September 10, 2015

G0058

SUBJECT: Update Report and Response to City Review Team Comments

RE: 1925 El Camino De La Luz, APN: 045-100-024
Santa Barbara, California

Name: Af Unit Weight: 105 pcf Cohesion: 0 psf

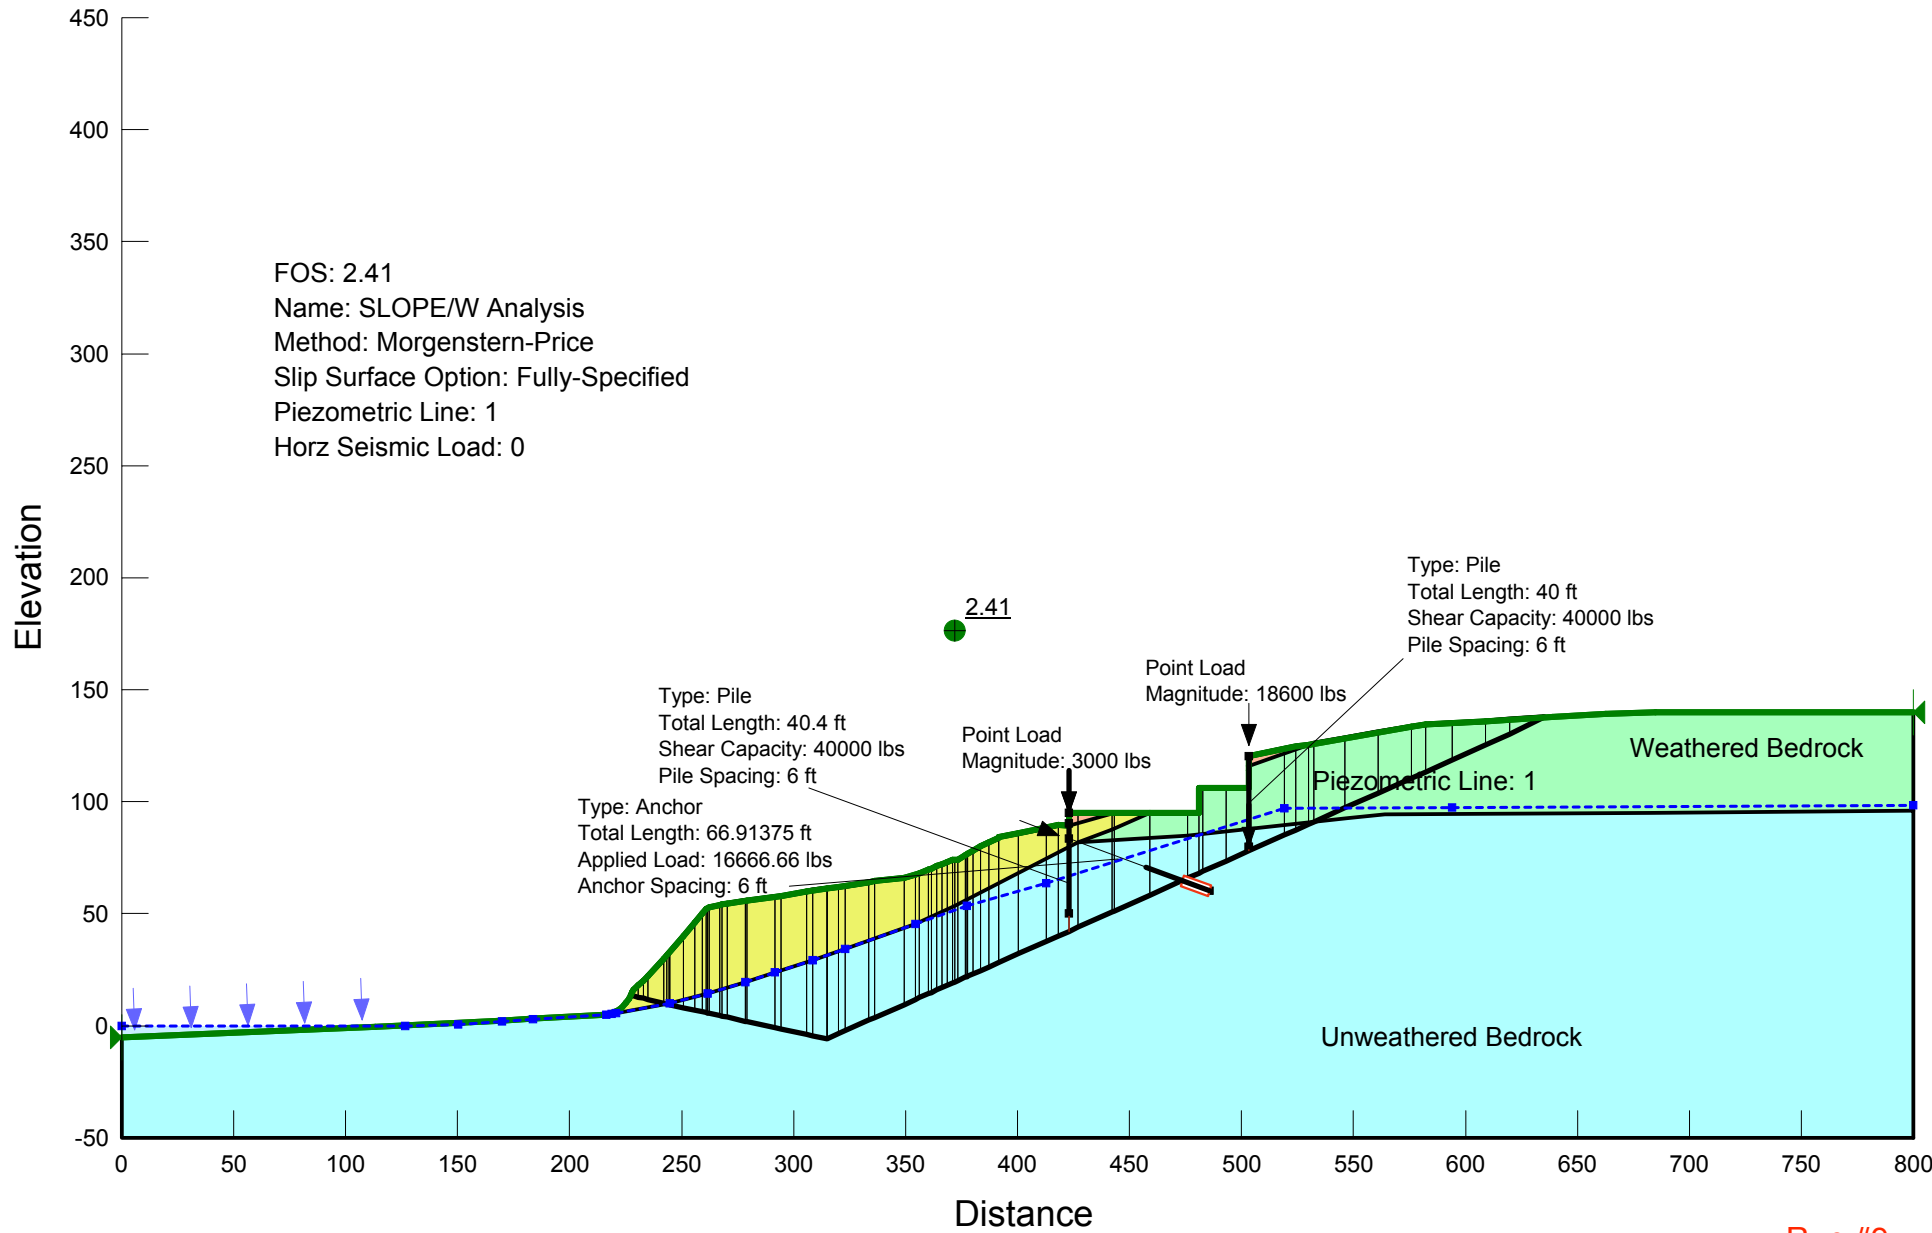
- 1. Review Comment 1: Preliminary Geologic and Geotechnical Investigation – Oct. 2012: Provide structural calculations that justify and confirm the use of the building loads specified on page 37 of this report; “We modeled the residential loads assuming two parallel contiguous point loads of 850 lbs, 20 feet apart.”*

2. *Review Comment 2: Preliminary Geologic and Geotechnical Investigation – Oct. 2012: Provide justification for the use of a base safety factor of 1.01 for the area of the landslide debris listed on page 38 of this report.*

CSA Response to Comment #1 – The preliminary point load values used to represent the proposed structures were reviewed by the Project Structural Engineer. Upon review and additional analysis, the Project Structural engineer updated the proposed building loads and recommended a point load of 3,018 pounds on the lower shear pin and a point load of 18,600 pounds on the upper shear pin (calculations included in Attachment A). Consequently, the slope stability analyses were updated to include these recommended point loads. In our October, 2012 Geologic and Geotechnical Report, a summary of the slope stability analysis results is presented in Table 3 on Page 38; Slope Stability Analysis (SSA) Run #'s 5 through #10 from this table have been re-calculated using the revised point loads. We have summarized the results of this analysis in the following table.

CSA Response – CSA utilized a factor of safety of 1.01 for the landslide debris for the purpose of back-calculating the strength of the basal rupture for forward analyses. Our slope monitoring reveals that the landslide debris is not moving, and thus, must contain a minimum factor of safety of 1.01 (and probably greater). CSA's monitoring includes periodic measurements of 2 slope inclinometers within the landslide debris, and periodic visual inspections of the landslide, neither of which show any evidence of recent movement. It is also noteworthy that Profile A-A' does not reflect grading and keyway stabilization of the western portion of the landslide, which likely has three-dimensional stabilization impacts that are not realized along the two-dimensional cross section line. In other words, the stabilization work performed in the mid-1980s along the western portion of the landslide included the excavation of a keyway below the landslide basal shear surface, and replacement with engineered fill that necessarily adds a stabilizing component to this portion of the landslide, which also likely adds a stabilization component to the entire landslide as a whole (three-dimensional effects). Consequently, while we have used $FS=1.01$ for the landslide debris, which is the minimum safety factor for a marginally stable slope, the actual factor of safety is likely greater than 1.01. Determining this FS with more specificity would entail a subsurface exploration program of all of the nearby properties containing the landslide debris to adequately characterize the actual safety factor, which was beyond the scope of our investigation.

Additional slope stability analyses were conducted on Slope Stability Section A-A' to estimate the approximate location of a potential failure surface with a Factor of Safety of 1.5. Two scenarios were considered: 1) the existing landslide in-place (current condition), and 2) the theoretical condition where the landslide is evacuated (conservatively not relied upon for any buttressing effect). The computer program,

material properties, method of analysis were the same as used previously and summarized in the October 2012 report. For the current analyses, the minimum slide surface depth was restricted to 10 feet to ignore shallow surficial potential failure surfaces and a block search method was used. The results indicate that for the landslide in-place (current conditions), the minimum Factor of Safety for the conditions analyzed was $FS = 2.16$.
